**Advisory No:** SAS307

# Service Advisory

**Product Line:** Snowmobile

**Subject:** Firecat Setup and Pre-Delivery Instructions - Corrections

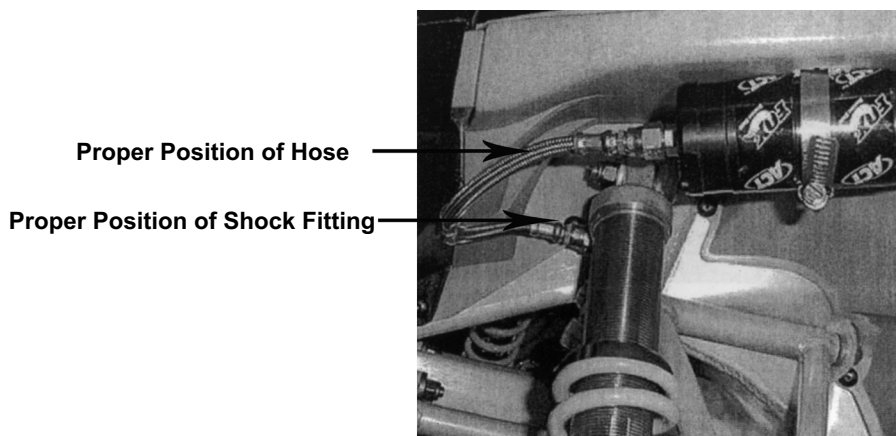
**First**, instructions need to be added for installing the ski shock/remote reservoir on the affected models. Although installing the ski shock/remote reservoir may not be difficult, it is still possible to incorrectly install the ski shock/remote reservoir. See the **NOTE** below.

■ **NOTE:** When installing the ski shock/remote reservoir assembly, make sure the hose connecting the reservoir to the shock faces toward the front of the ski and the 90° elbow shock fitting faces toward the front of the snowmobile. See Fig. 1 for the proper positioning of the hose and shock fitting.
